Aftersales Bulletin

A 03 2026 05 – RR31 Rear Seat Belt Fixing Bolt Connection Check

USA - TECHNICAL CAMPAIGN (**RECALL 26V-143**) - Complete as soon as possible, using all available means to recall the vehicle for correction.

RR31 REAR SEAT BELT FIXING (Bench Seat)

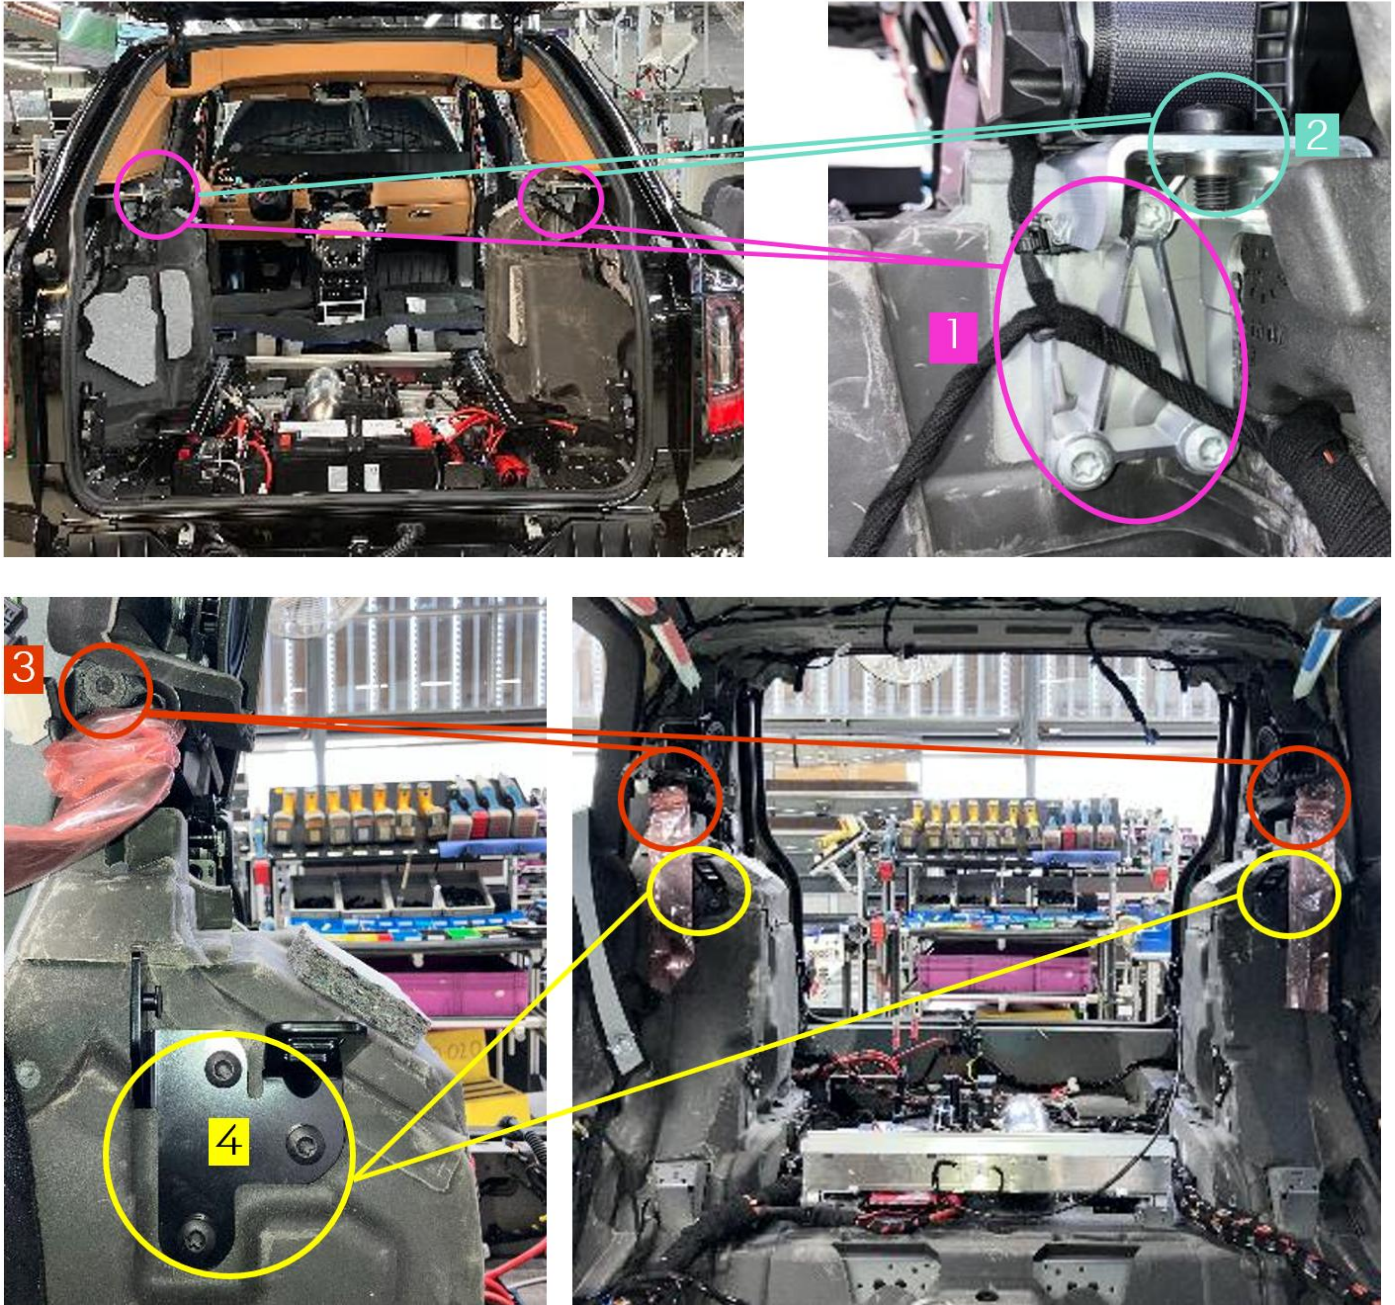
The fixings that require checking are shown on page 3 or 5 depending on variant (Bench or Individual seats).

If any of the fixings of positions 1, 2 or 3 are found loose or not torqued to specification – please inspect the automatic seat belt mechanism (belt webbing, retractor, etc.) and check for any damage. If damage is found, please replace the seat belt mechanism.

If the fixing of position 1, 3 or 4 is found to be loose, retorque the fixing without replacement.

If the fixing of position 2 has not been tightened to the required torque, it needs to be replaced.

Fixing	Number	Torque
Seat Belt Module x3 REP-REP-P-7211380-RR31-LHS REP-REP-P-7211381-RR31-RHS	1	42.0 Nm
Seat Belt Module x1 REP-REP-P-7211380-RR31 REP-REP-P-7211381-RR31	2	42.0 Nm
Seat Belt Deflector x1 REP-REP-P-7211380-RR31 REP-REP-P-7211381-RR31	3	42.0 Nm
Bench Striker x3 REP-REP-P-5147151-RR31 - Carpet removal REP-REP-P-5147161-RR31 - Carpet removal	4	38.0 Nm
